Coed Darcy Monitor Phase 57 RRWCC

**Prepared for:
Coed Darcy Limited**

**Prepared by:
AECOM Infrastructure & Environment UK Limited**

Contract Name:	Coed Darcy Monitor	RFI No:
Contract Number:	GNP/NJR/13773-2	Date Raised: 25 June 2015
Subject:	Review of Atkins' Validation Report for Monitor Phase 57	
To:	Michelle Lee	Atkins
Cc:	Mike Poland	Atkins
From:	Rhys Mander	AECOM

PHASE 57 BOUNDARY PLAN

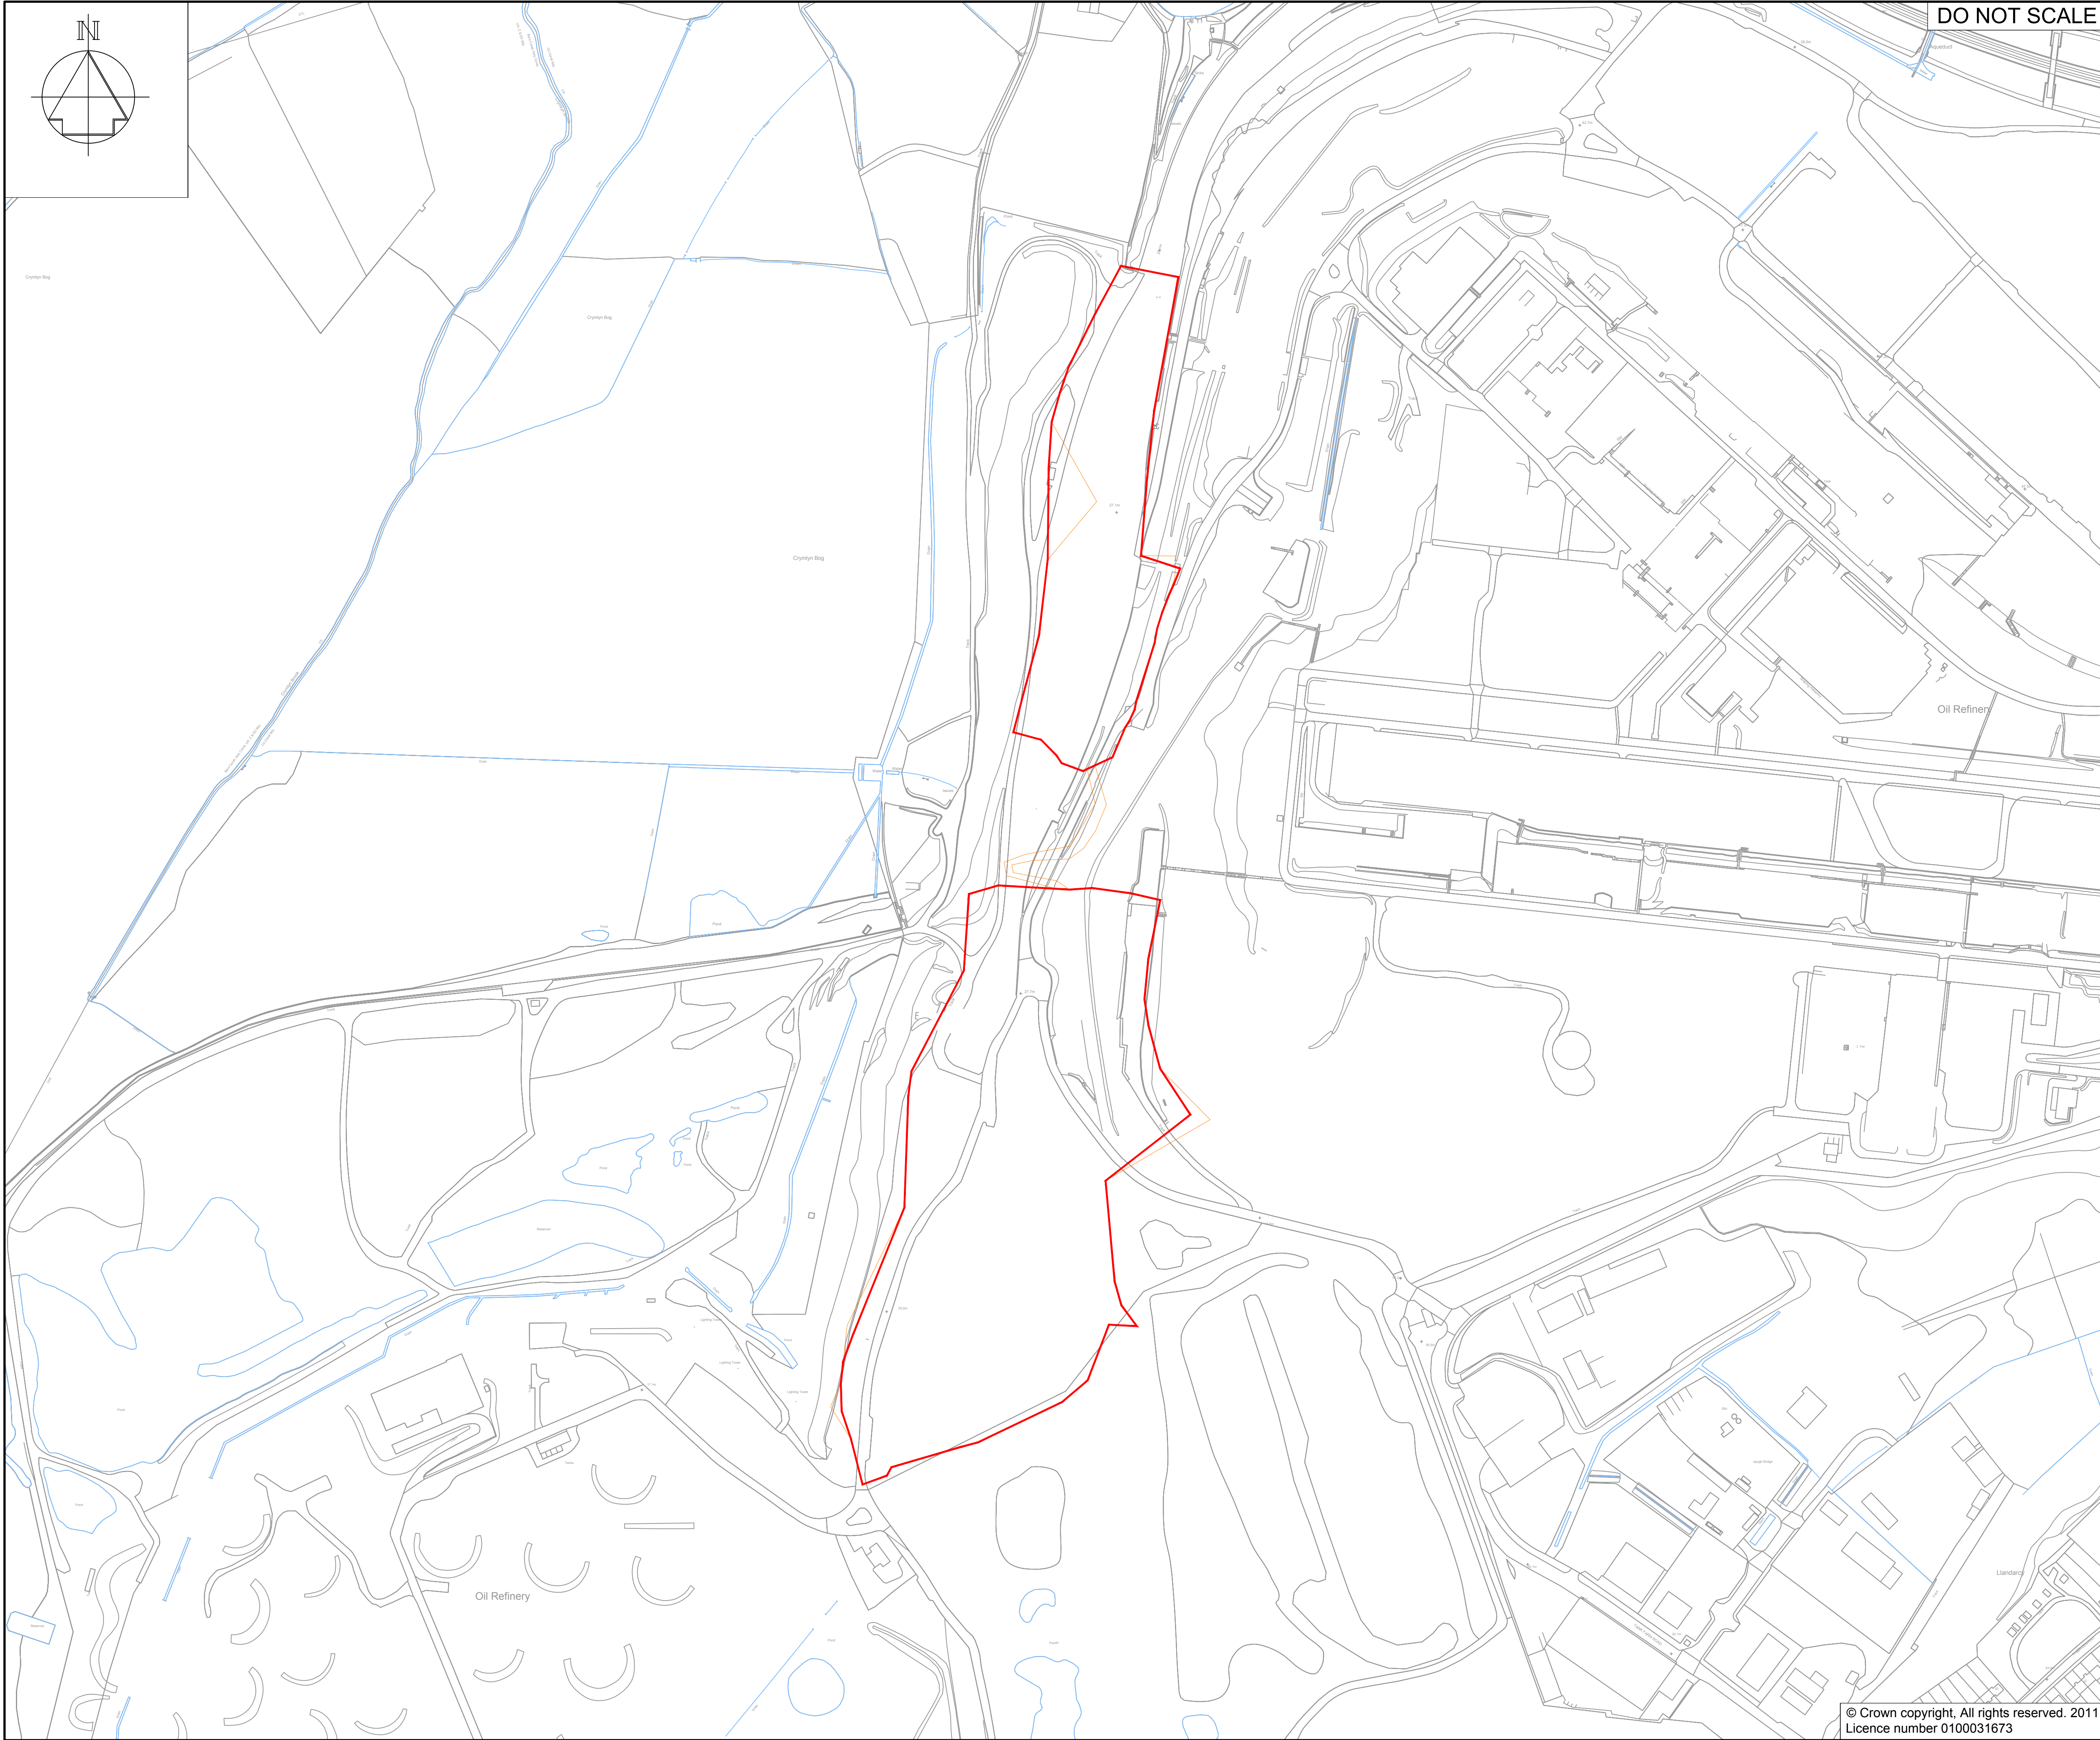
- With reference to the phase boundary drawing it is noted that the proposed phase boundary overlaps with the boundaries for phases 14 and 39. In the case of Phase 14, the RAP certificate has already been issued and hence it is suggested that the phase boundary for Phase 57 should be amended accordingly.
